Subject: Facility Survey of the White Pine County Courthouse, Ely, Nevada

FACILITY SURVEY

Name of Facility: WHITE PINE COUNTY COURTHOUSE

Date of Survey: September 13, 2007

2nd FLOOR: JURY ROOM:

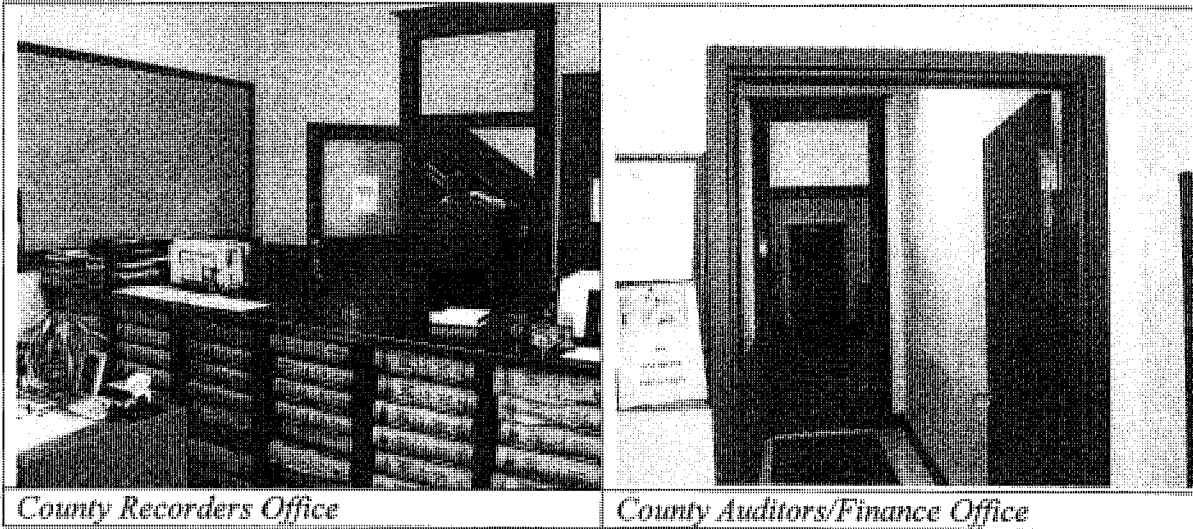
Problem: The jury room is small and confined and the windows allow open viewing into and out of the jury room; there is no emergency lighting in place.

Recommendation: The windows allow for distractions and communication both ways which could defeat the security integrity for a trial. The windows should be frosted to prevent jurors from being distracted and external coverings to obstruct viewing from the outside. Emergency lighting should be installed.

District Attorney's Property/Evidence

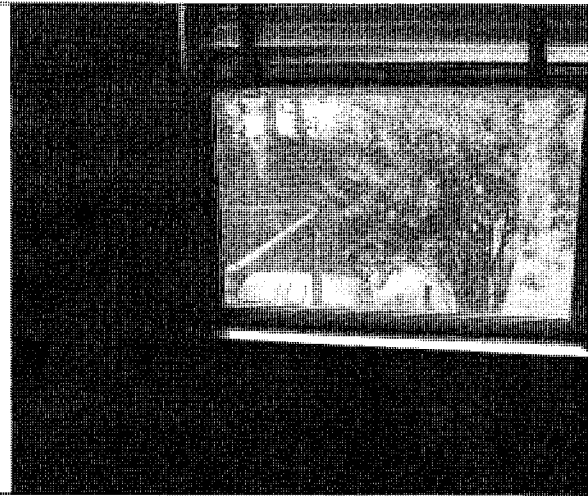
Problem: The DA uses this office space to store items, including firearms, until legal matters have been finalized. There are no security measures in place.

Recommendation: The doors should be reinforced with solid core doors and MedCo type locks and the entry door camera monitored. The door should be alarmed and a duress alarm installed in case of forced entry. The windows should also be alarmed and the exterior protected with high grade security screening to prevent easy access. Each entry should be documented to preserve the security integrity of all stored items.

Public 1st Floor Area

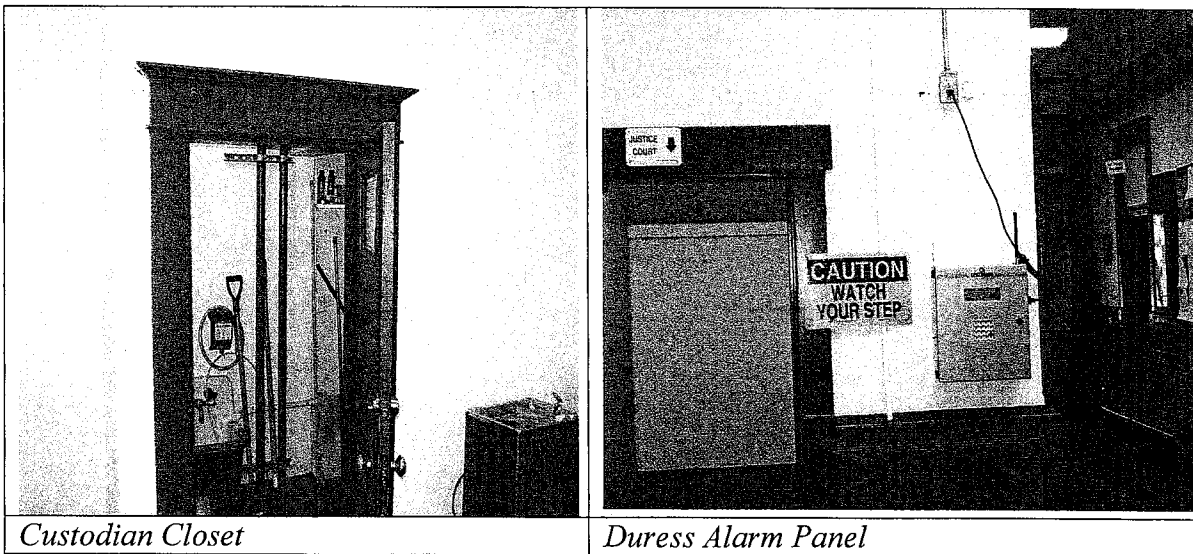
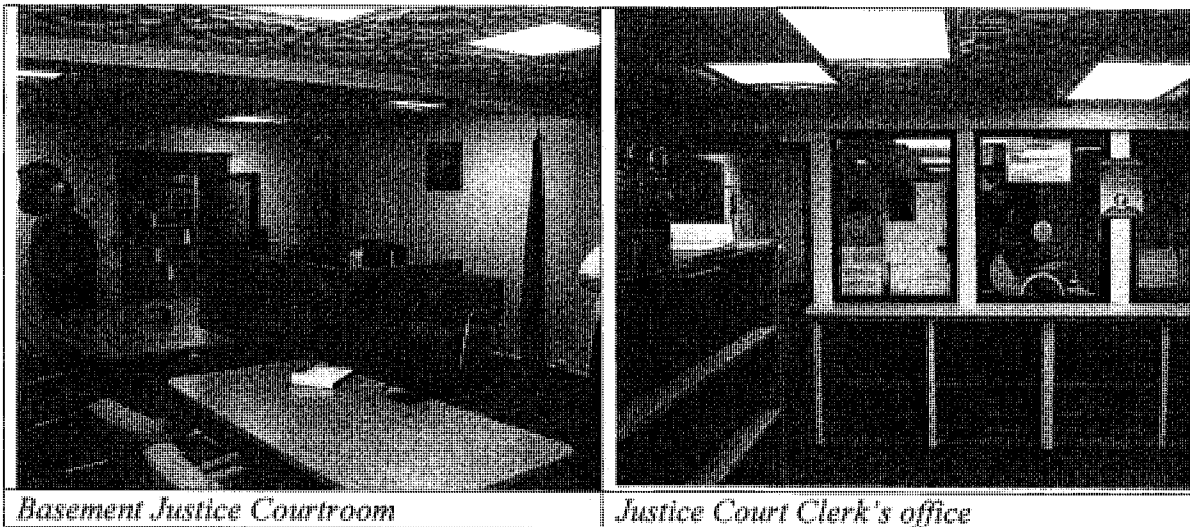
Problem: These areas are unsecured and are located in public space.

Recommendation: Secure all these areas with reinforced cabinets and proper security locks. All the exposed plumbing and electrical wiring throughout the facility is an issue onto itself, but unsecured items like these can be addressed immediately.
